Freightliner
Service Bulletin

General Information

Improved H01 and H02 lines have been introduced for EPA07 MBE4000 engine installations in vehicles manufactured prior to 8/17/09. The new lines supersede all old ones. If either the H01 or H02 line fails, both lines must be replaced at the same time.

Fig. 1, Bracket Installation

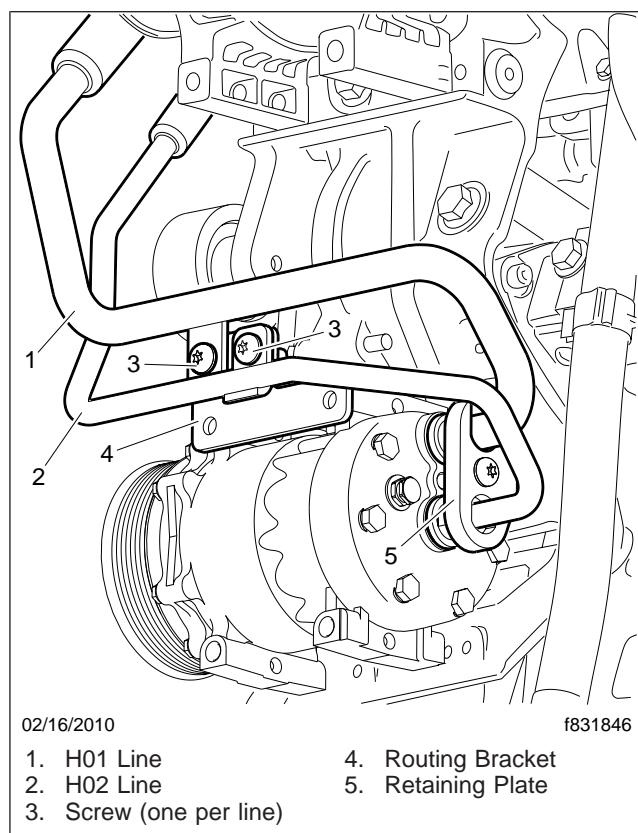
A new routing bracket and hardware are required to upgrade to the new lines. [Figure 1](#) shows the bracket installation. [Table 1](#) lists the routing bracket information.

1. Remove the original lines.
2. Install the new bracket on the compressor mounting bosses, as shown in [Fig. 1](#). Tighten the fasteners 15 to 19 lbf-ft (21 to 26 N·m).

Fig. 2, Checking the Fit

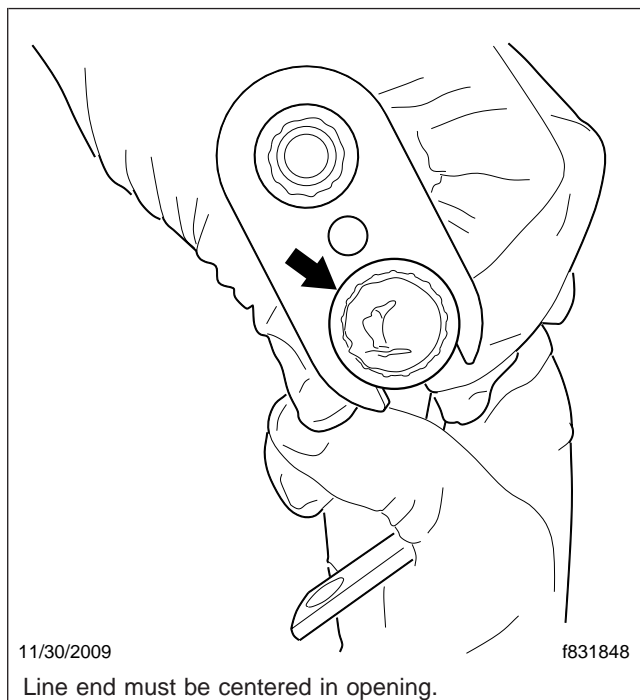
3. Check the fit of the H01 line in the retaining plate on the H04 line. See [Fig. 2](#). If it fits properly, no modification is needed. If it does not fit, modify the retaining plate as described in "H04 Line Retaining Plate Modification" below.

Fig. 3, Retaining Plate Modification

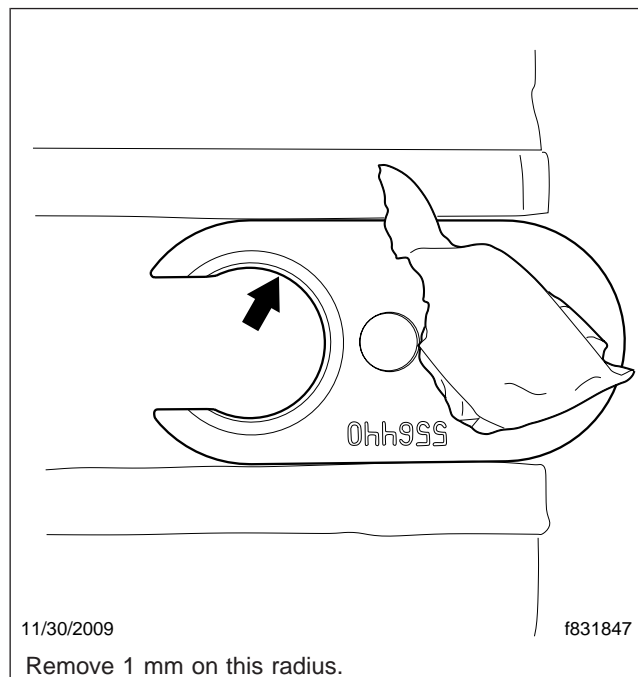
3. Using a suitable tool, enlarge the radius of the part of the retaining plate that surrounds the H01 line end by 0.039 inch (1mm). See [Fig. 3](#). This is approximately the same as the chamfered edge on the inside radius of the retaining plate.
4. It must be centered to form a proper seal when installed.

Do not take too much material off of the retaining plate. Make sure that material is removed equally around the radius. Improper modification of the part may cause the line to seat incorrectly leading to a leak in the A/C system.
